Re: 26 Ralston Road, Palm Beach – Mod2022/0518 – Agenda Item 3.6

I write in response to the Assessment Report prepared in relation to Mod2022/0518 at 26 Ralston Road, Palm Beach, being item 3.6 on the agenda for meeting of the Development Determination Panel (**the Panel**) to be held on Wednesday 28 June 2023. The application is before the panel with a recommendation of refusal. However, this recommendation is based on an Assessment Report that is fundamentally flawed and includes a series of inaccuracies, inconsistencies and misrepresentations that unfavourably skew the outcome of the assessment. These are best addressed in response to the Draft Reasons for Refusal, as follows:

Figure 10: Photograph from standing position of second floor living area at 8 Ebor Street, Palm Beach and the blue height pole for Lot 4 in the background

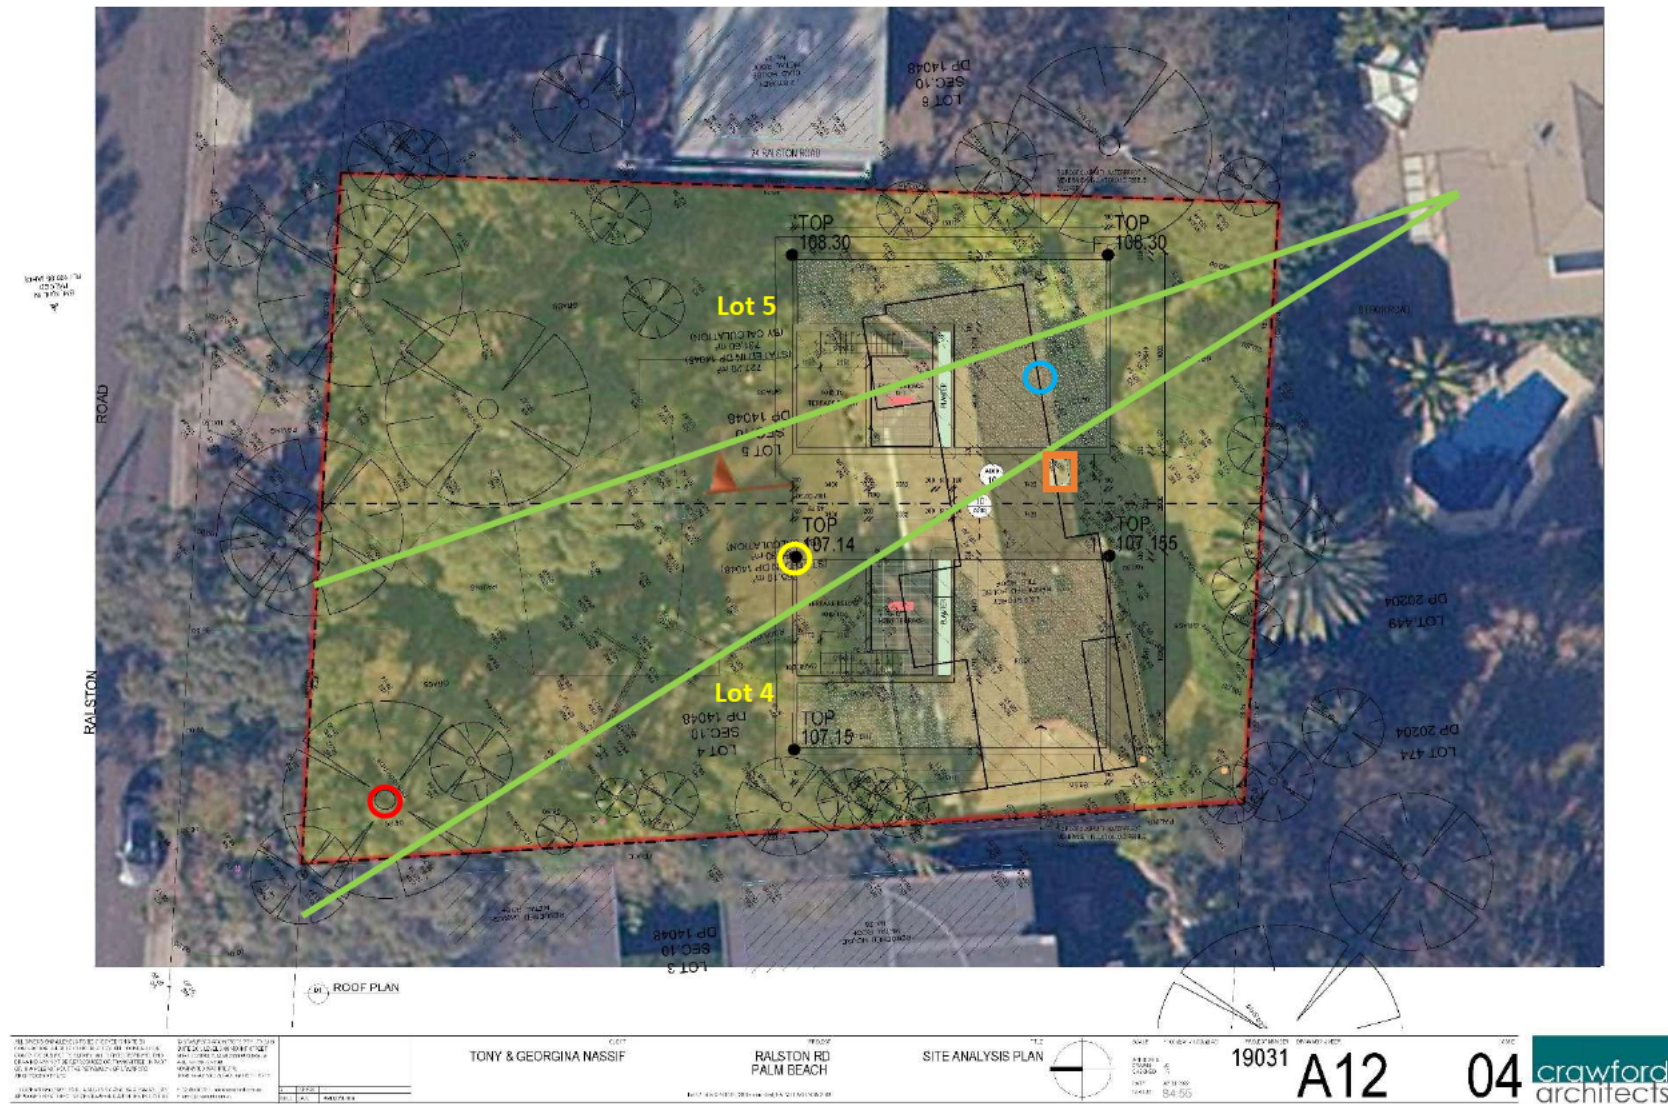
The Assessment Report asserts that the increase to the height of the dwelling on Lot 4 will result in unreasonable impacts upon views from 8 Ebor Road. The Assessment Report relies upon the height pole that is visible in Figure 10 on page 391 to confirm that the increased height of the dwelling on Lot 4 will result in the obstruction of water views from 8 Ebor Road that would otherwise be retained by the current approval.

However, as demonstrated in **Annexure One** and as confirmed in the Minutes for the DDP meeting at which the original application was approved, it is the dwelling on Lot 5 that results in impacts to views from 8 Ebor Place and not the dwelling on Lot 4, as suggested in the Assessment Report. As confirmed in Figure 9 on Page 390, the height pole visible in Figure 10 represents the north-eastern corner of the dwelling on Lot 4, with the dwelling on Lot 4 to be located to the left of the pole, and not the right, as indicated in red by the Assessing Officer.

The height pole visible in Figure 10 has a certified height of RL107.14m AHD. The dwelling on Lot 5 was approved with a parapet height of RL 107.85m AHD, with a roof top planter and a balustrade at RL 108.4m AHD within the view corridor in question. As such, Council can be reasonably satisfied that the view from Level 2 of 8 Ebor Road was already lost as a consequence of the approved development, with any further impacts to the Level 2 views associated with the proposed modification limited to views of the sky.

The view corridor nominated in green has been assumed based on Figure 10 in the Assessment Report (reproduced below), and the following key markers:

- The certified location of the height pole (circled in yellow)
- The sewer vent stack of the existing dwelling (circled in blue).
- Tree 8, the Sydney Blue Gum at the north-east corner of Lot 4 (circled in red).
- The end of the ridgeline of the existing dwelling (where the hip of the roof begins), just visible to the right of the sewer vent stack.
- The existing chimney stack (outlined in orange), which is not visible in Figure 10.
